NEUTRON PRODUCTS inc

Re: Response to Second RAI
Docket No. 71-9215
EPID No. L-2017-LLA-0133

"5.1 Provide additional information regarding the methodology and criteria used to determine whether source material is suitable to be loaded.

FIGURE 1.e.

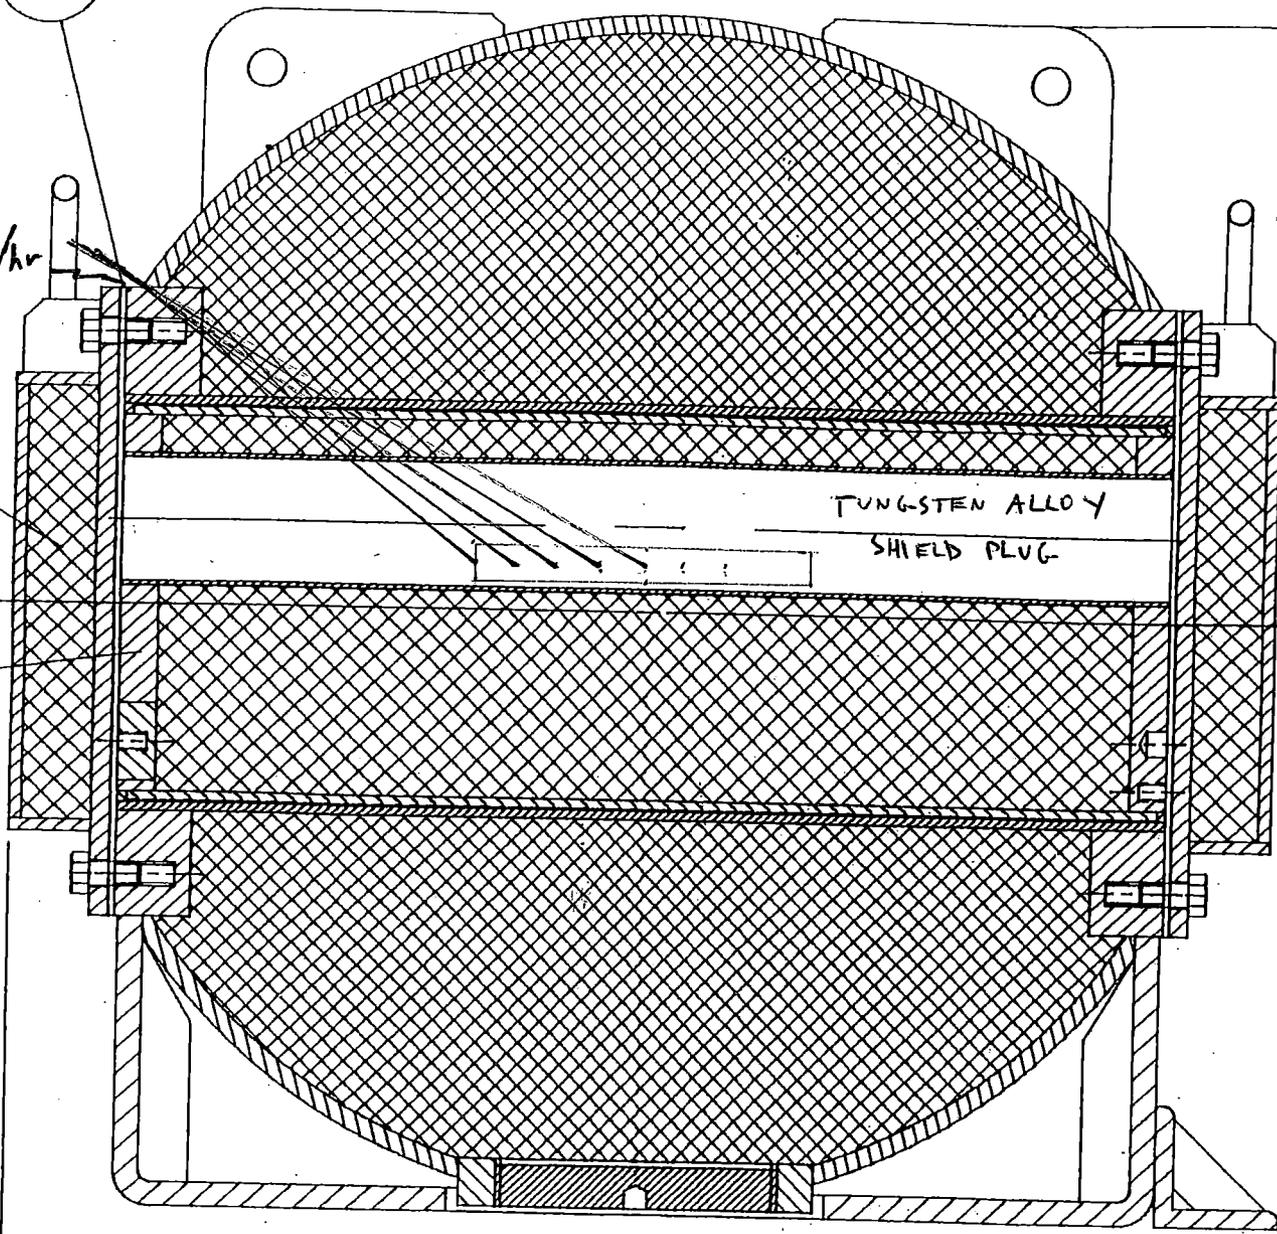
Staff analysis shows that a pencil source with the maximum activity limits in the CoC Condition 5(b) will not meet the dose rate requirements of Title 10 of the Code of Federal Regulations (10 CFR) 71.47(a). Although the applicant confirmed this in an RAI response (ADAMS Accession No. ML18218A429), the applicant did not provide separate analysis or measurements showing that a package which does not meet 71.47(a) will meet the requirements of 71.47(b). Therefore, the applicant needs to provide the criteria or the process

by which the maximum activity that can be transported in a pencil source configuration is determined.

This information is necessary to determine compliance with 10 CFR 71.47."

As shown in the attached sketches, for this configuration, the highest dose rate is expected to be found at the top of the bolt flange for the end caps. As a result, we will focus on Figure 1.e.

Taking measurements from the sketch shows that the overall distance from the tip of the source (where we have located our first 1175 Ci point source) to the top of the flange is approximately 9". Of that, approximately 3.25" is tungsten alloy, 3" is lead and 2.75" is steel.

So, the first hypothetical 1175 Ci point source contributes 58 mR/hr to the contact dose rate at the top of the flange.

The same process is used for the next few 1175 Ci point sources, with each source being spaced approximately 0.875" apart. As we move back in the source, we also have to account for self attenuation, or the amount of shielding provided by the source itself. For the purposes of these calculations, we assume the cobalt metal has similar shielding properties to those of steel or iron. Using the process described above, the second source (at a measured distance of approximately 9.75" from the top of the flange) results in a dose rate at the flange of 36 mR/hr. The third gives 7 mR/hr and the fourth gives 4 mR/hr. Calculations were stopped at this point, with the total being approximately 110 mR/hr.

To estimate the contact dose at the surface of the package itself, we will use the inverse square law. The center of the source is approximately 12" from the outside of the cask, and approximately 24" from the outside of the overpack:

$$110 \text{ mR/hr} (12^2 / 24^2) = 27.5 \text{ mR/hr, or approximately } 30 \text{ mR/hr.}$$

~110 MR/hr
